ADDENDUM NO. 4

Perry Meridian High School Phase 1 – Student Activity Center
401 W. Meridian School Road
Indianapolis, IN 46217

PROJECT: PERRY MERIDIAN HS PHASE 1
PROJECT NUMBER: 24173P
DATE OF ADDENDUM: April 16, 2026

RE: Addendum 04

C-9.5

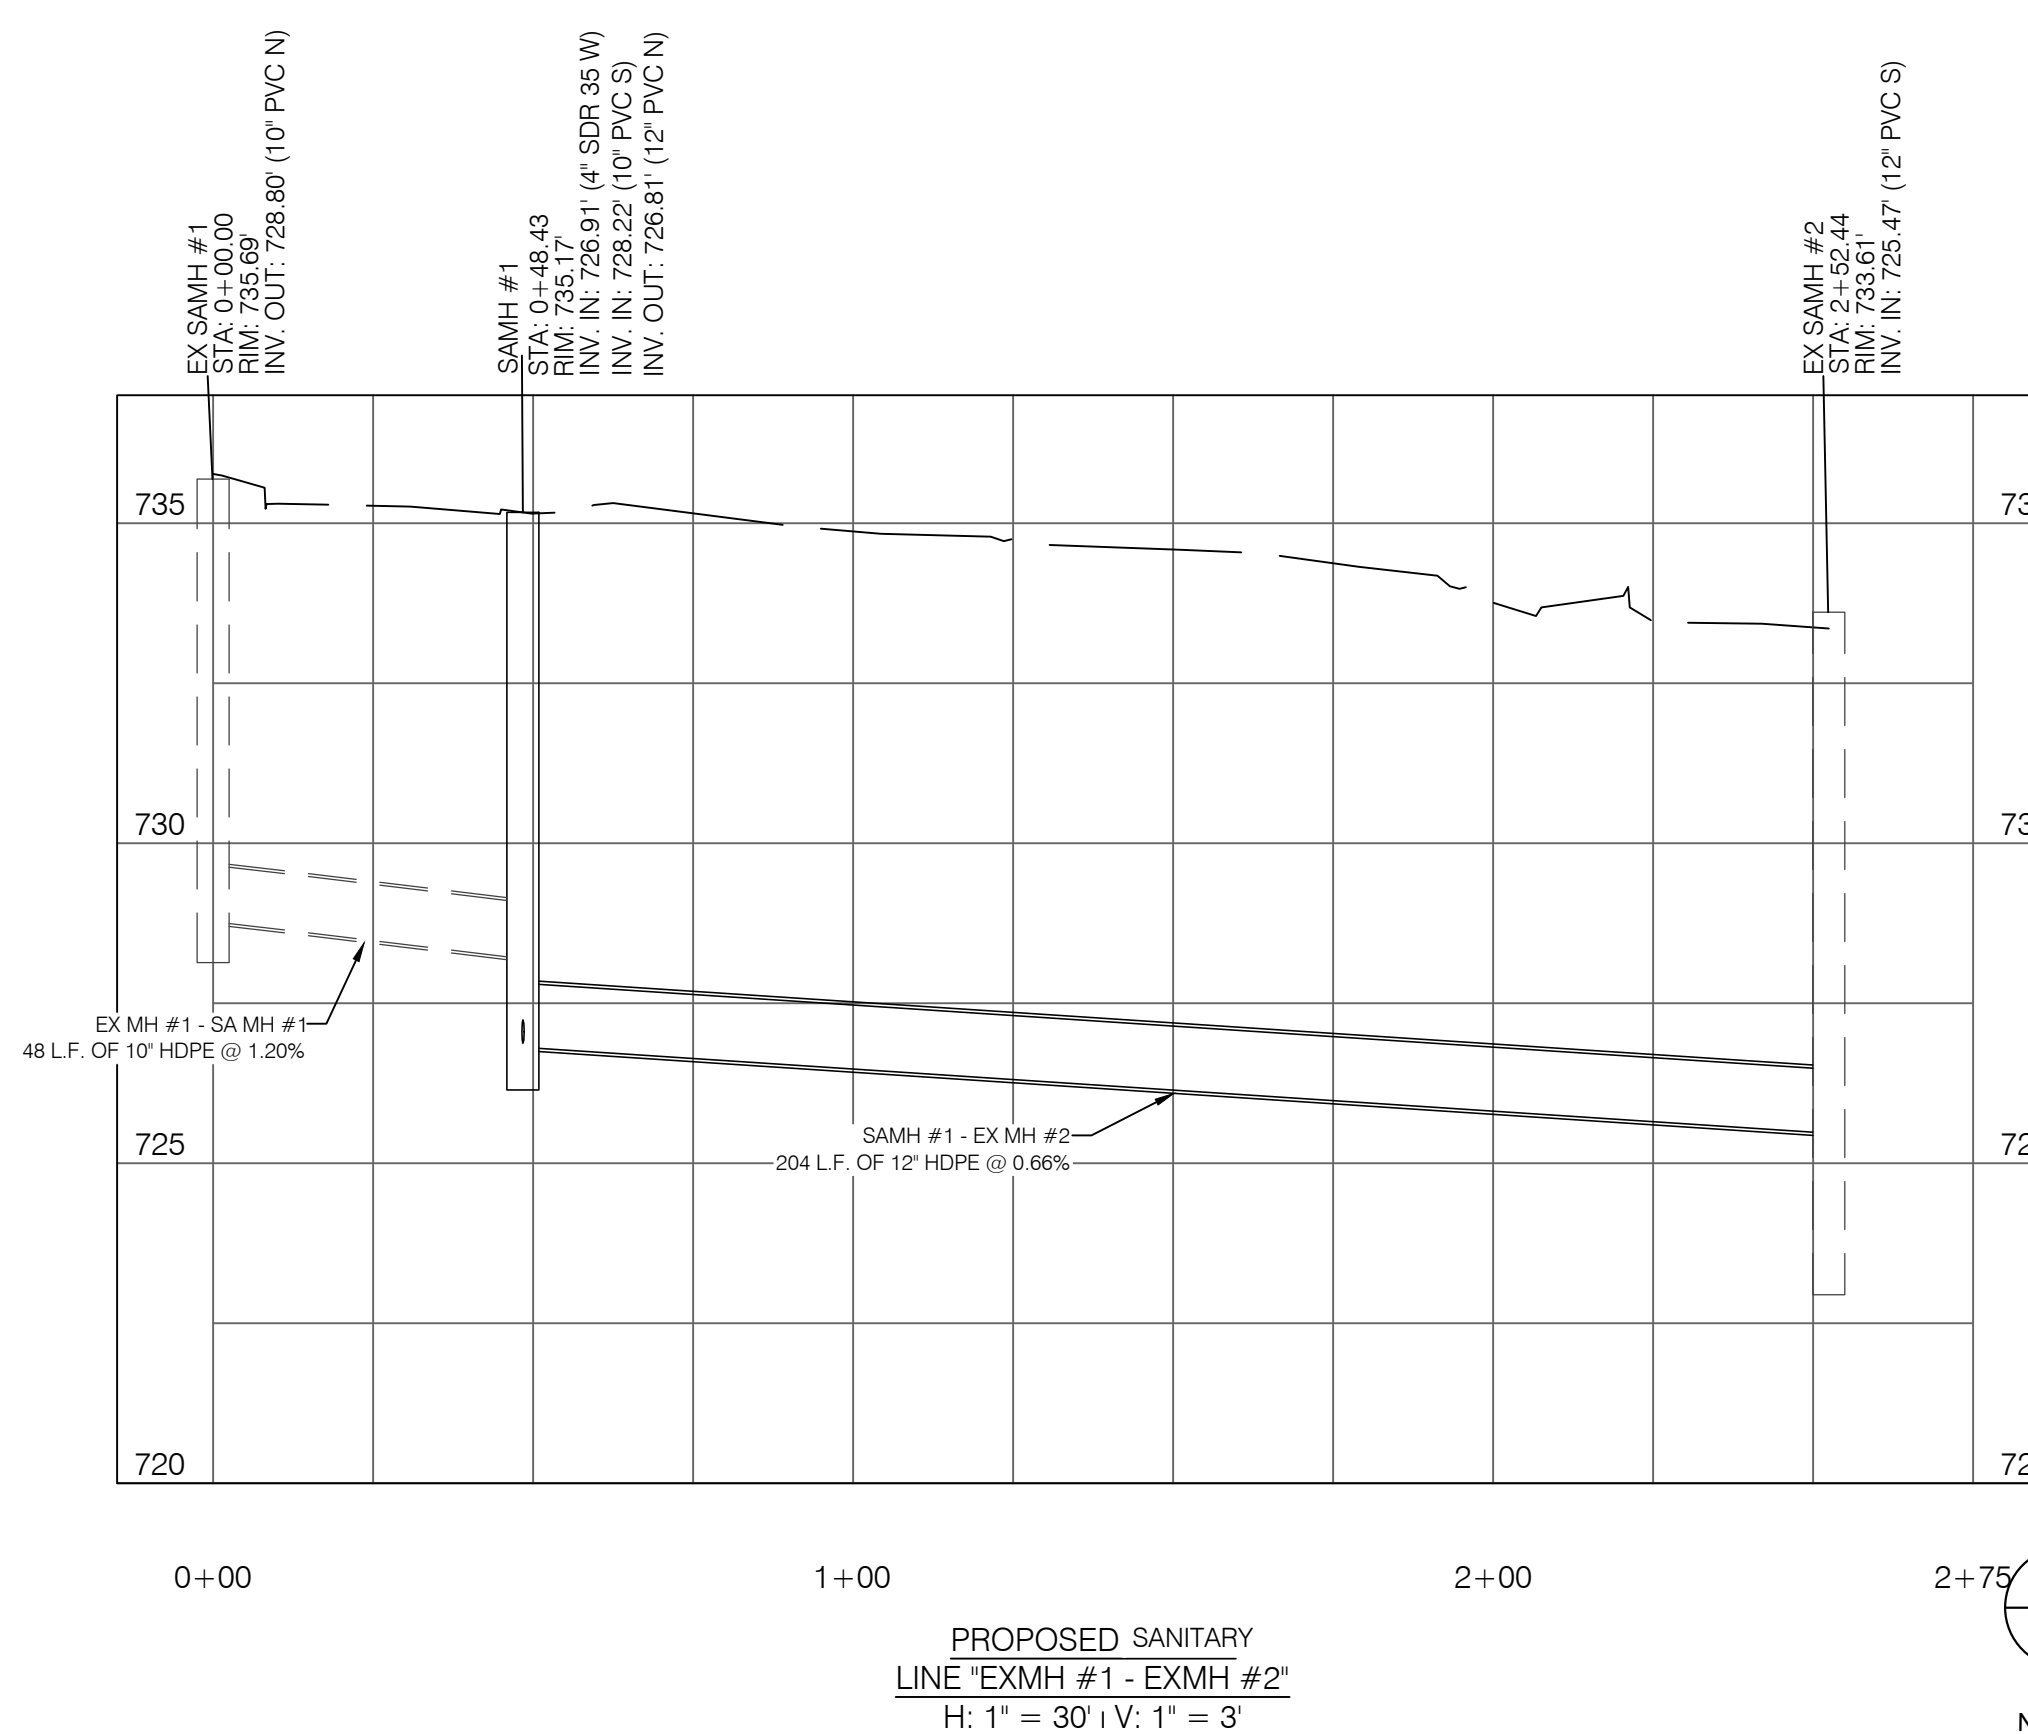
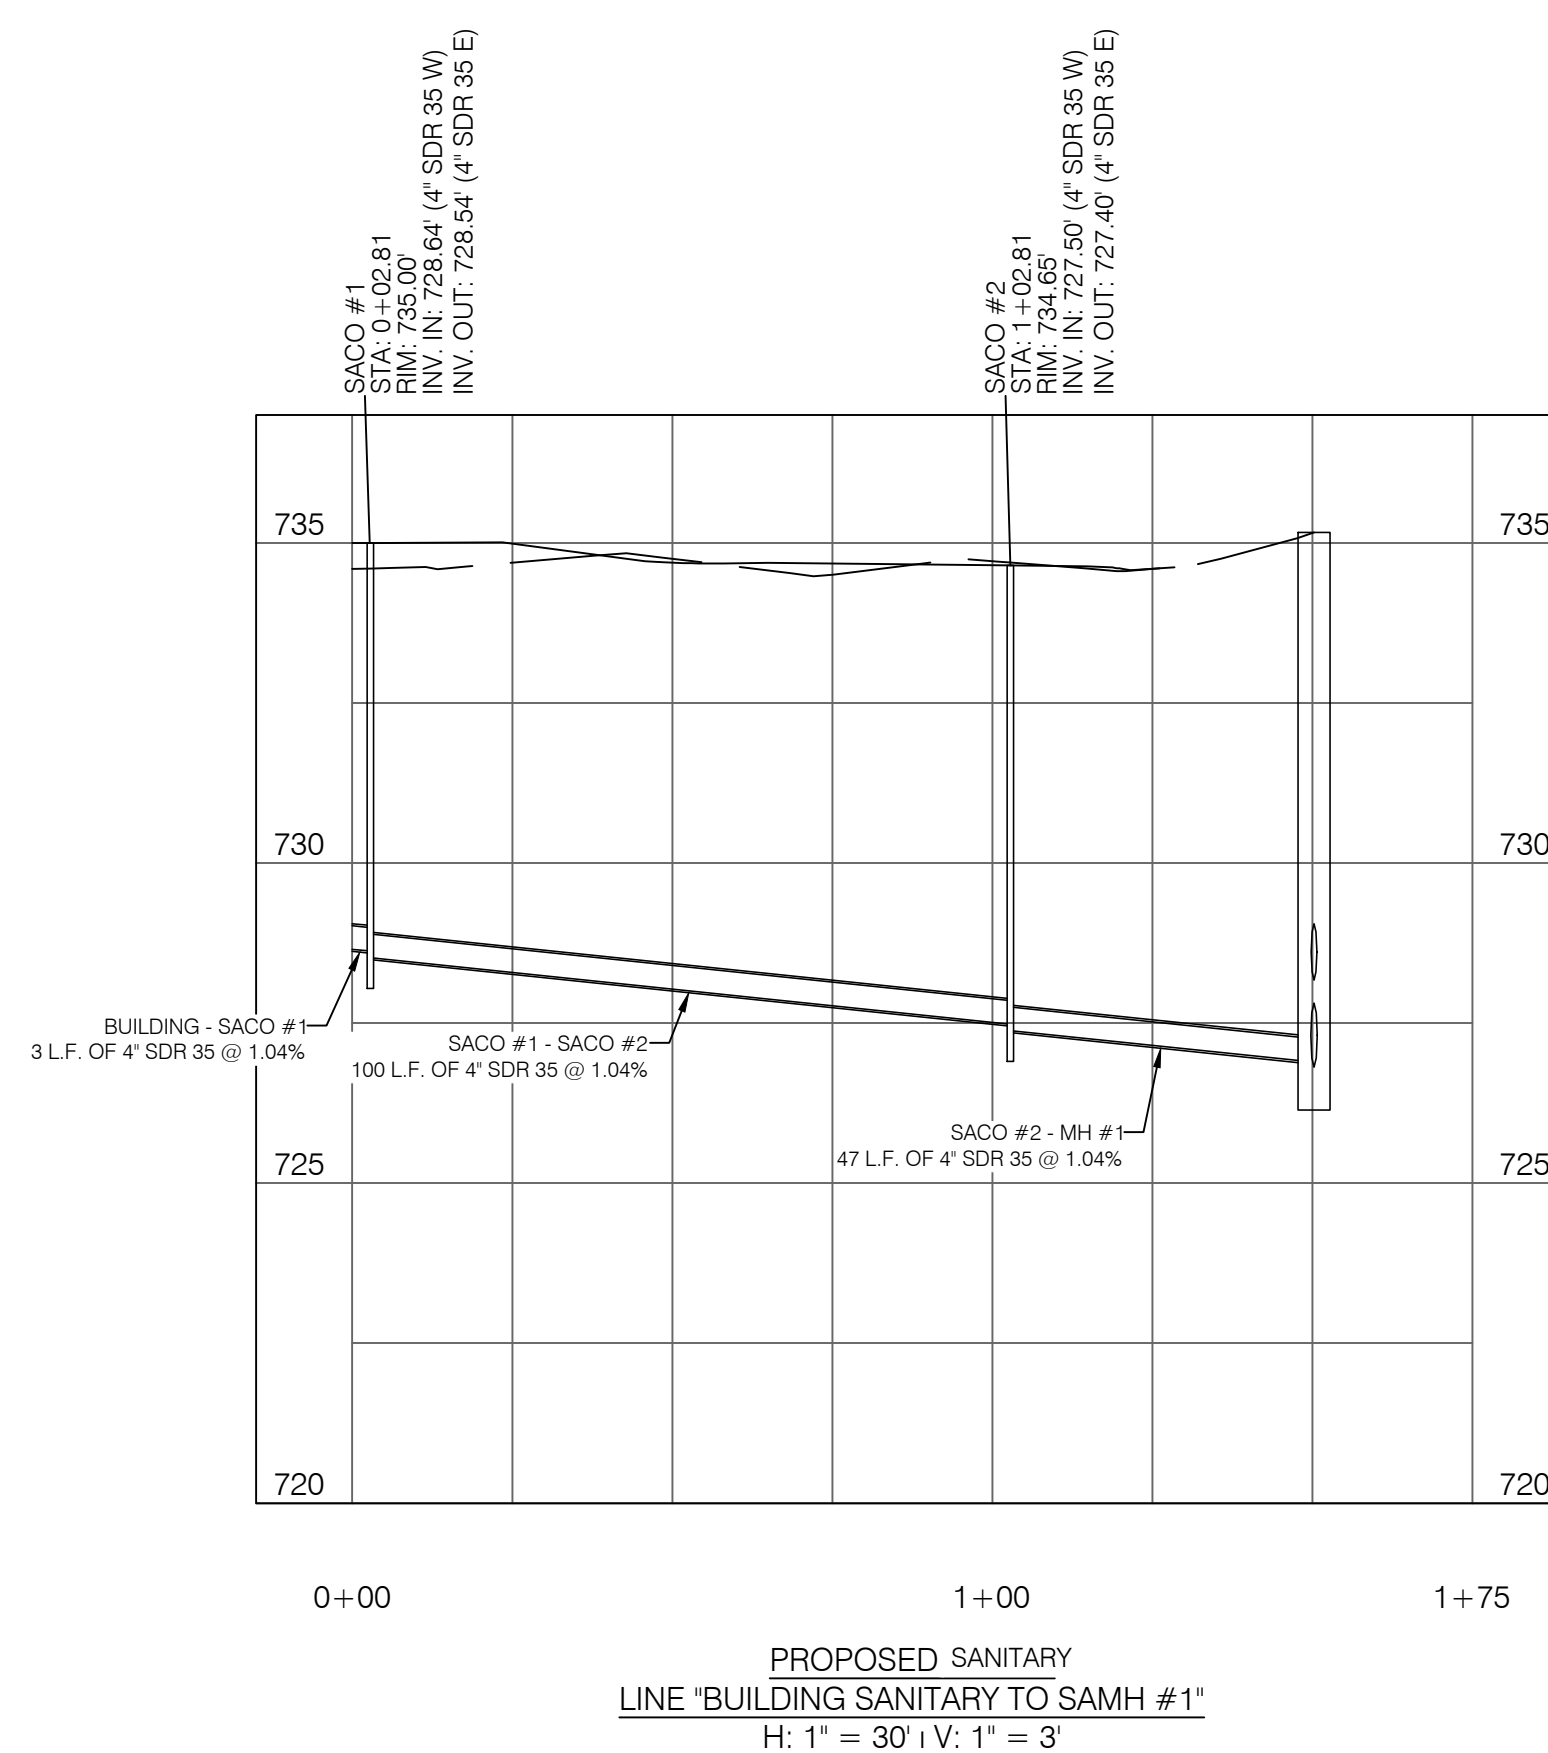
Sheet C-9.5

- Sanitary profiles and structure tables added.
